# HISTORIC AND DESIGN REVIEW COMMISSION

**HDRC CASE NO:** 2016-488  
**ADDRESS:** 215 CLAUDIA ST  
**LEGAL DESCRIPTION:** NCB 2876 BLK 1 LOT 7  
**ZONING:** RM-4,H  
**CITY COUNCIL DIST.:** 1  
**DISTRICT:** King William Historic District  
**APPLICANT:** Ricardo McCullough  
**OWNER:** Vidal Gonzalez  
**REQUEST:**

The applicant is requesting a Certificate of Appropriateness for approval to:

1. Construct a single story addition to the rear of the primary historic structure.
2. Construct a two story apartment at the rear of the lot.

GARAGE LEFT ELEVATION  
SCALE: 3/16" = 1'-0"

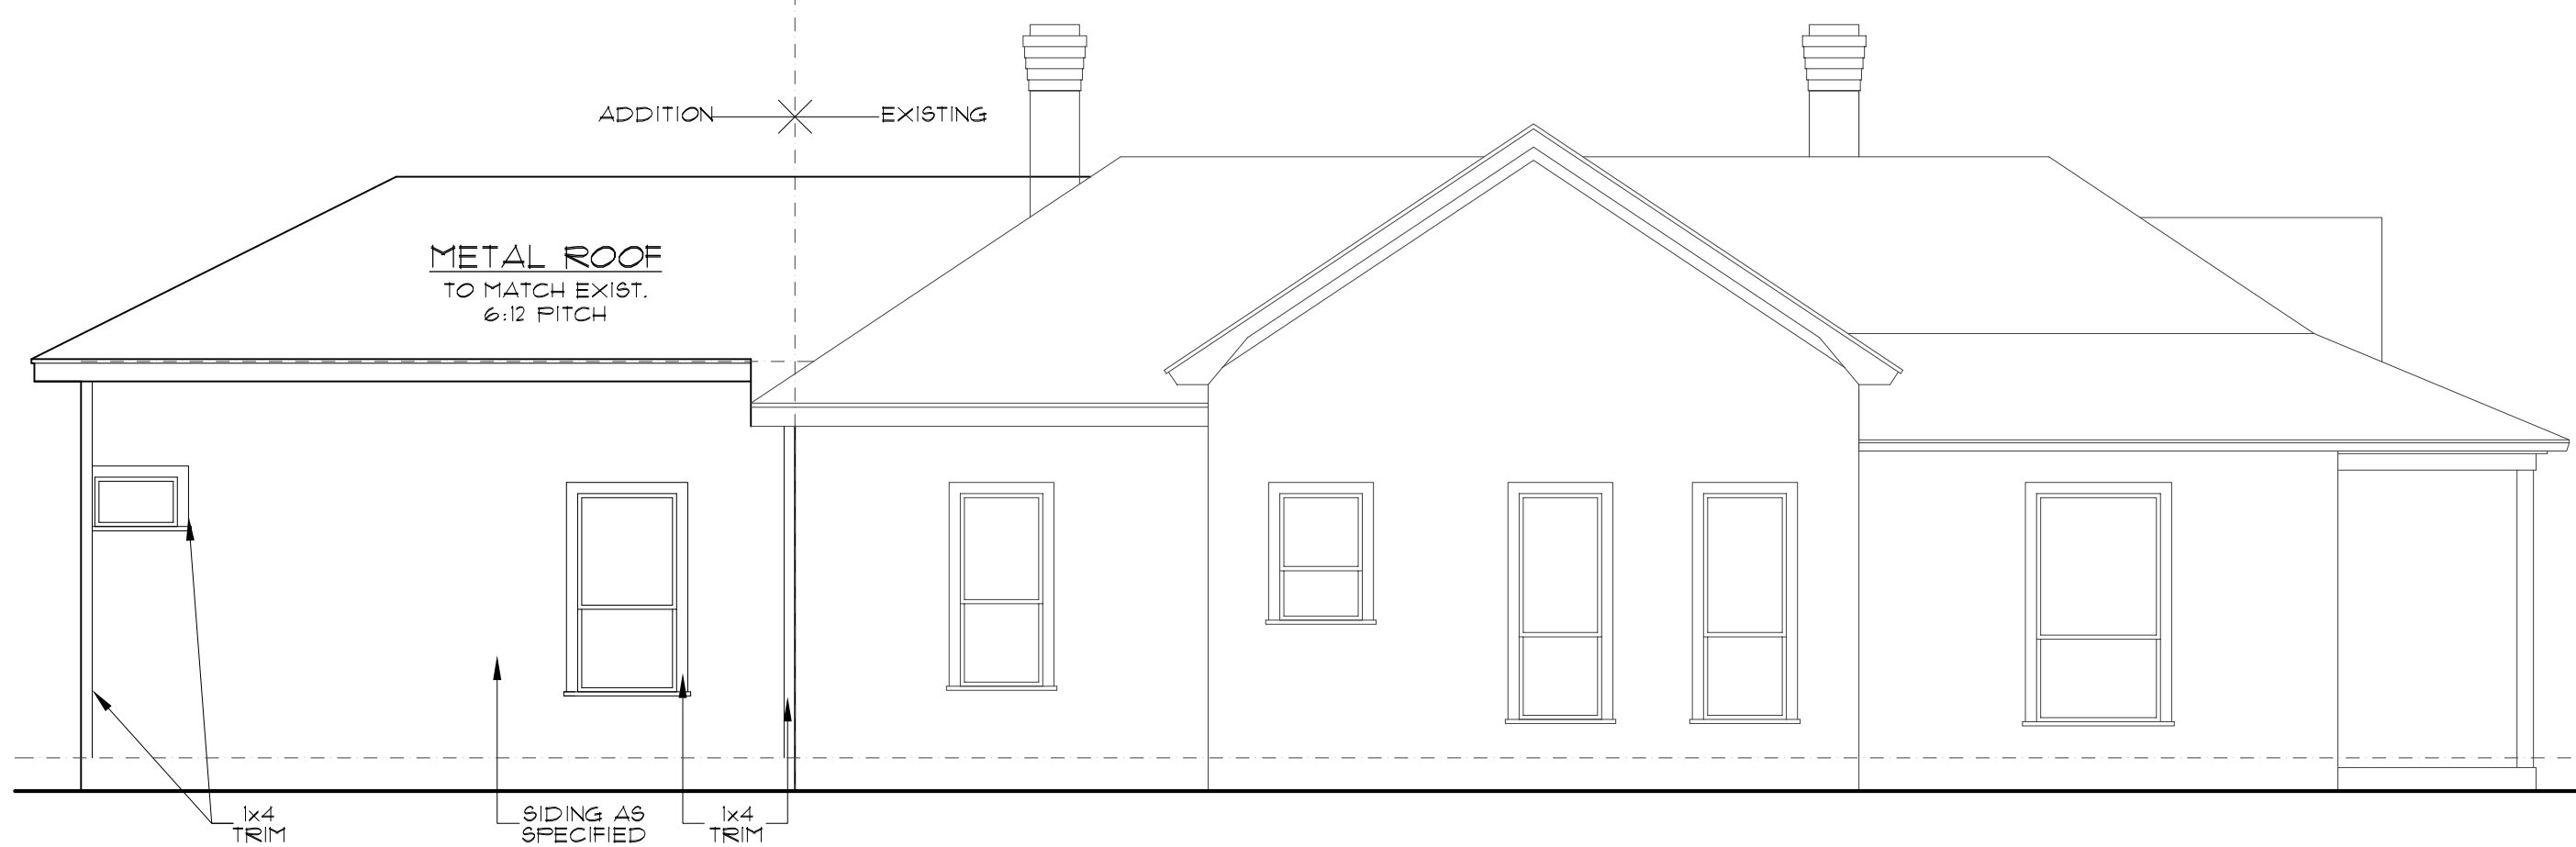
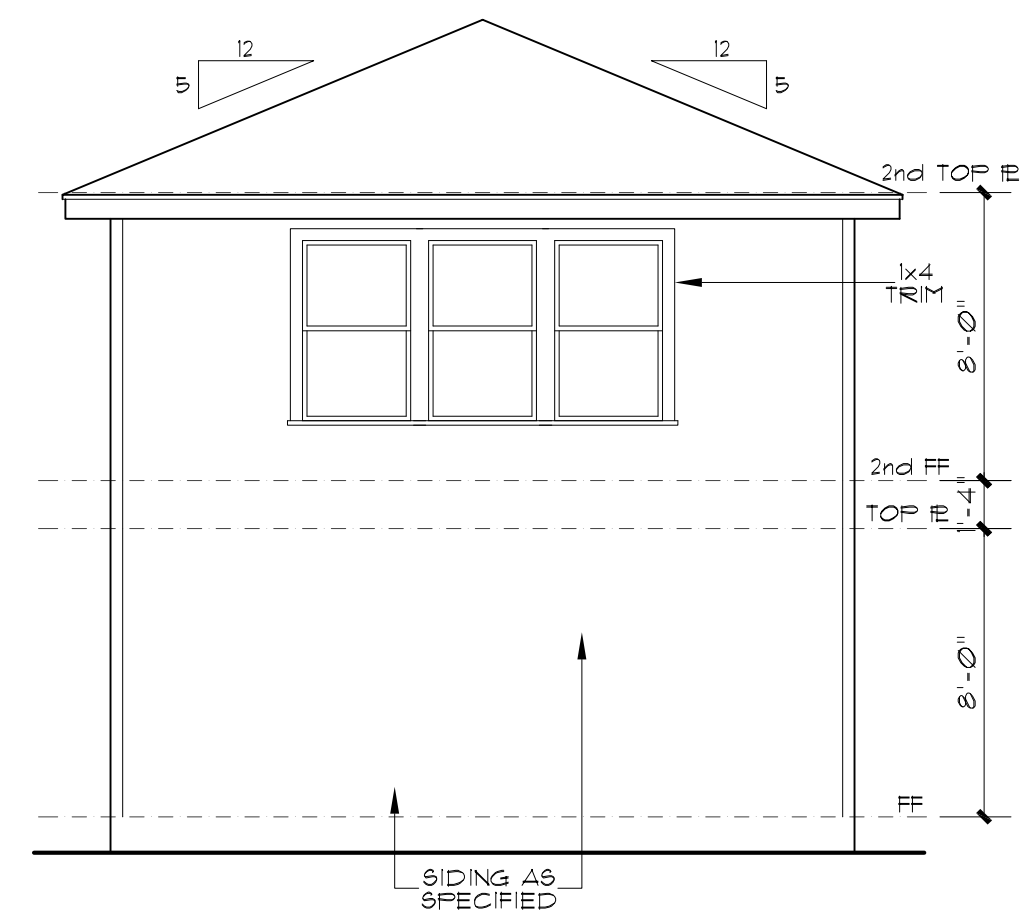
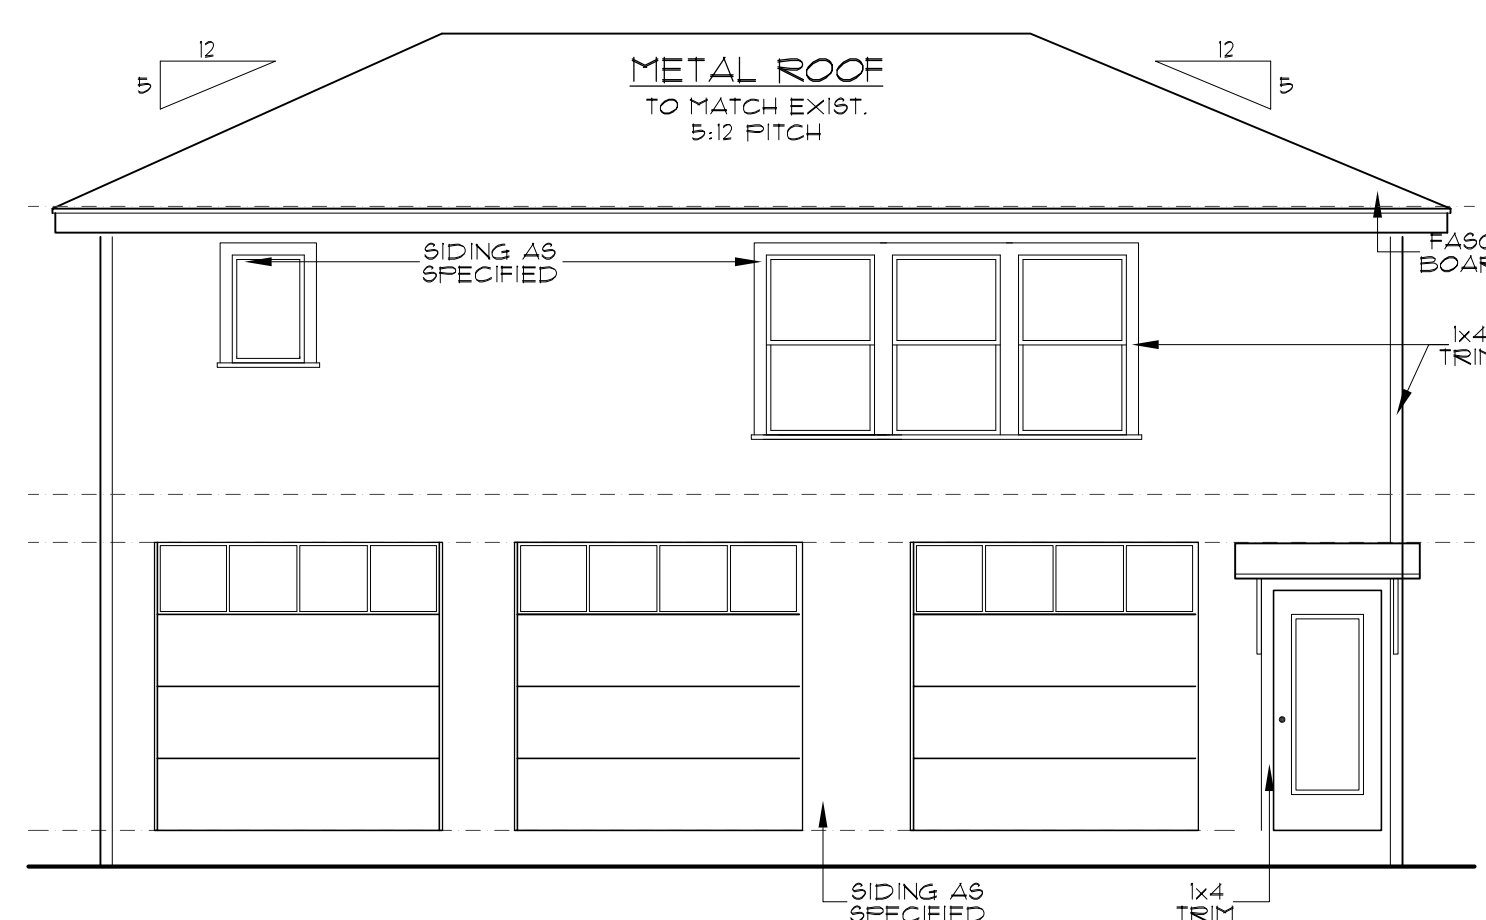
- e. **TWO STORY GARAGE** – The applicant has proposed for the garage to feature a hipped roof similar to that of the primary historic structure, window openings similar to those found on the primary historic structure and individual overhead rolling garage doors. Staff finds this appropriate.

Staff recommends approval of items #1 and #2 based on findings a through g with the stipulation that the applicant include additional window fenestration on both the rear façade of the proposed rear addition and the ground floor of the proposed garage.

REAR ELEVATION  
SCALE: 3/16" = 1'-0"

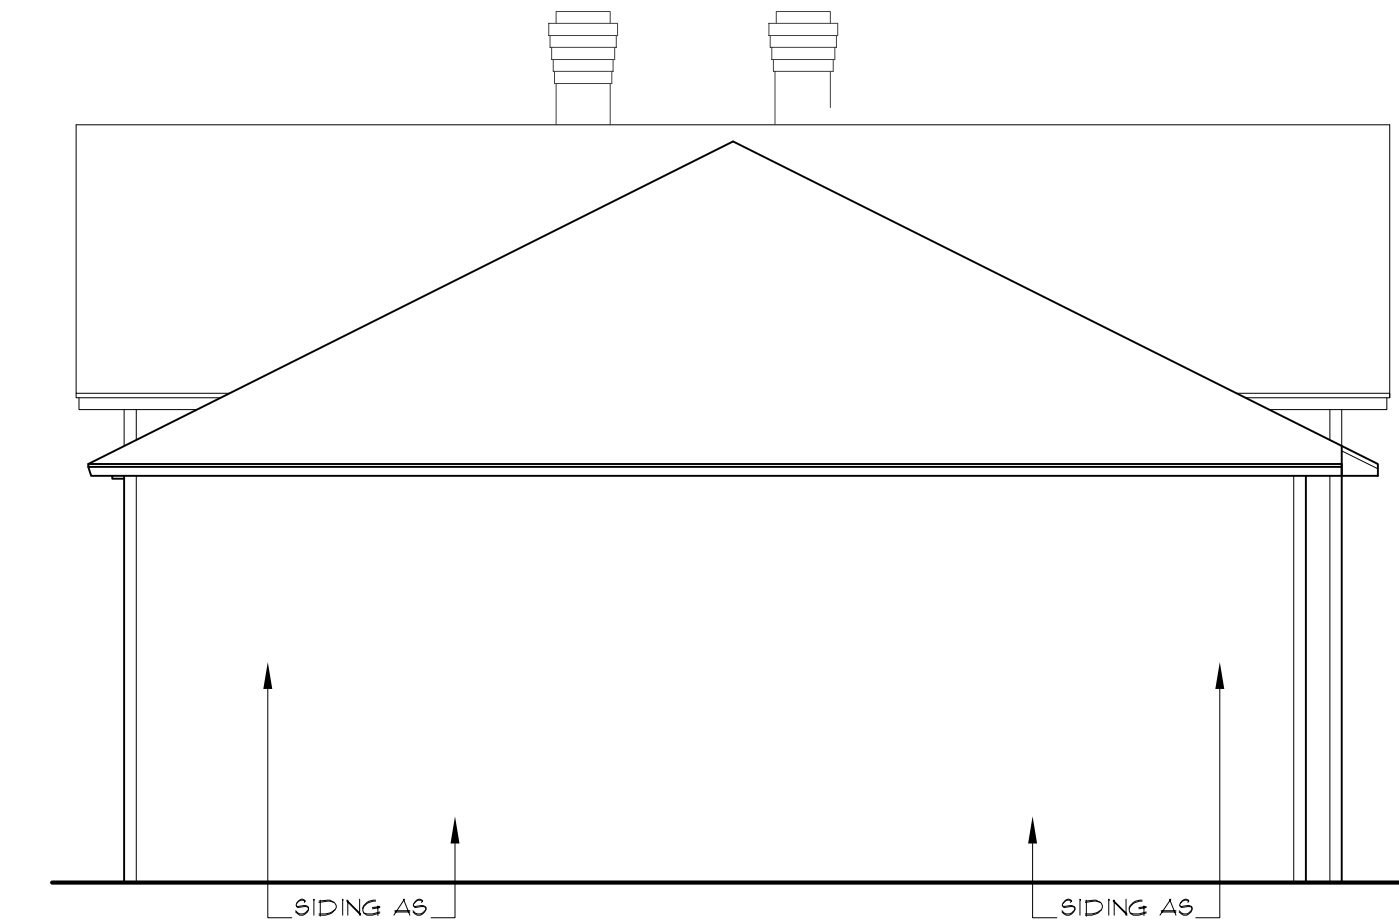
- f. **ADDITION FENESTRATION** – The applicant has provided elevations of the proposed addition that generally features window openings that are comparable to those of the primary historic structure. The Guidelines for Additions 4.A.i. states that the shapes of window opening should relate to those of the primary historic structure. Staff finds that the applicant should propose additional fenestration on the rear façade of the proposed rear addition.
